To: -
From: Jay James
Date: 13 February 2026
Copy: -
Our reference: PC7029-RHD-ZZ-XX-ME-R-0011
Classification: Project related
Checked by: Mark Lever-Green

Subject: Growing Baldock - Interim Transport Response to Consultees

Reference: Hertfordshire County Council
Highway Authority - Interim Statement

Revised Indicative Access Drawing

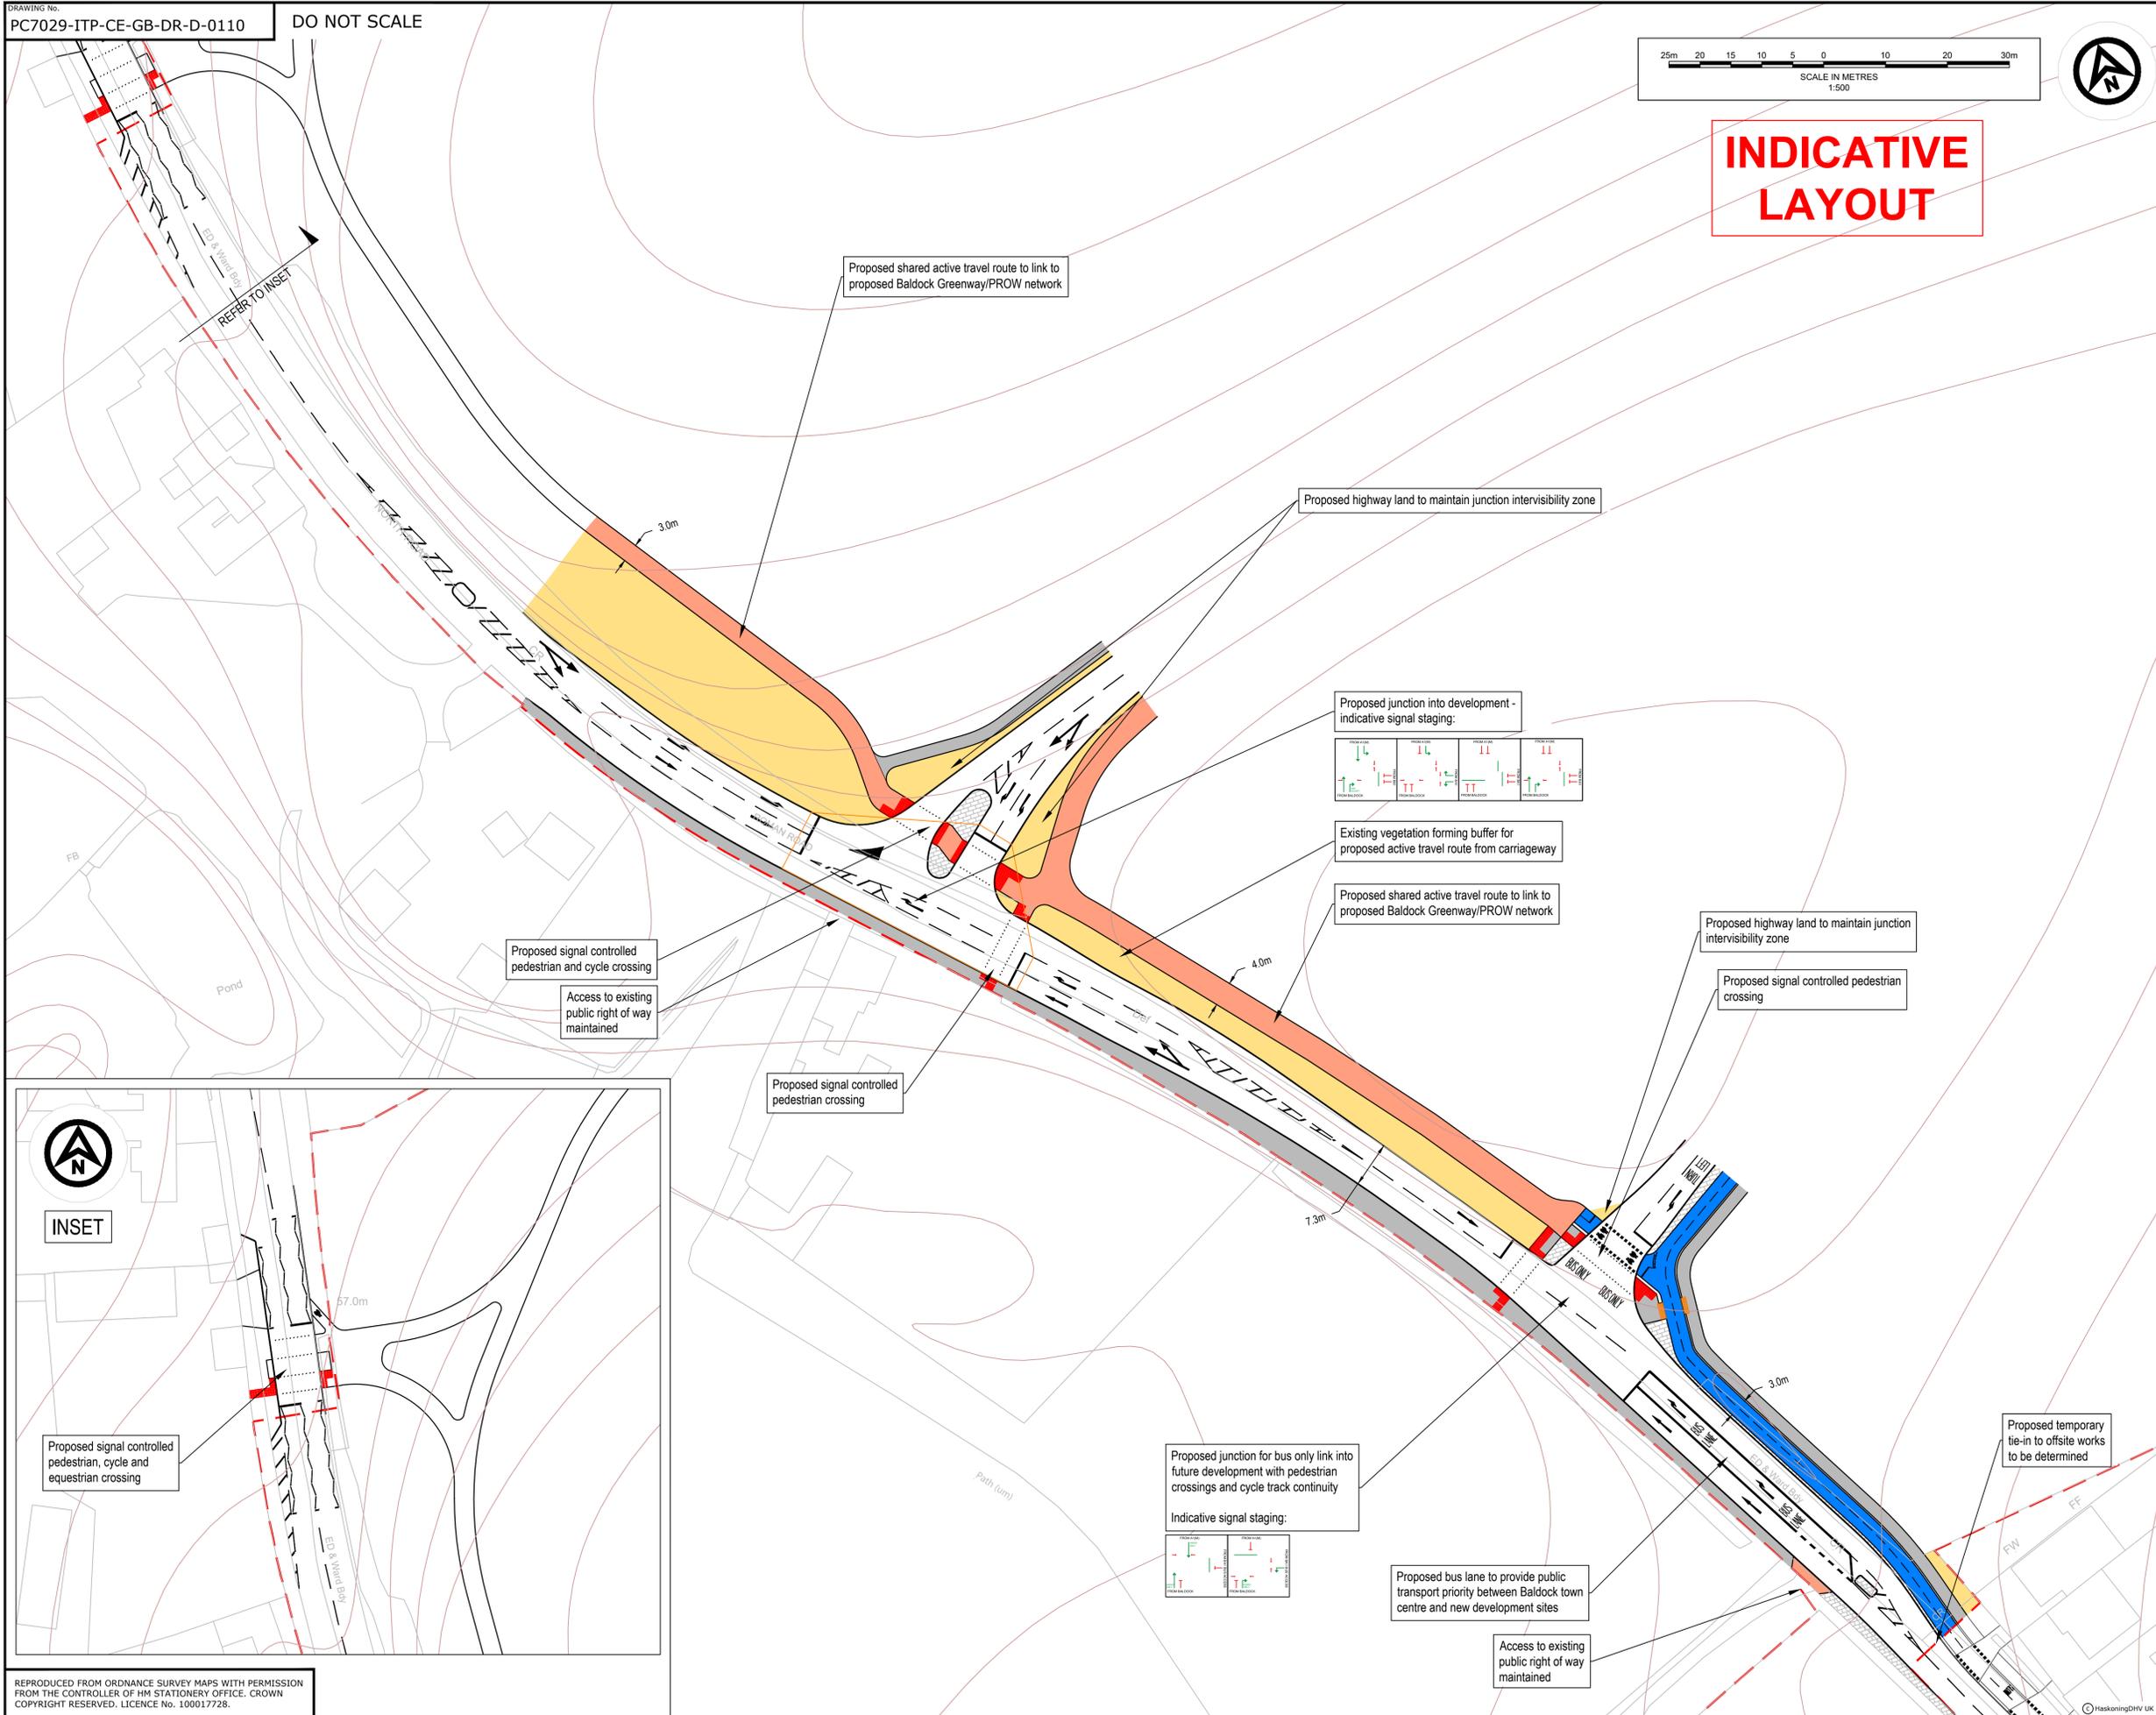
- The staggered crossings proposed provide better amenity for pedestrians by reducing waiting times.
- Revised drawings of North Road have been prepared, included in **Appendix D**, and these show a southbound connection from the shared path. Northbound cyclists will be able to access Football Close and Icknield Way using the dropped kerbs.
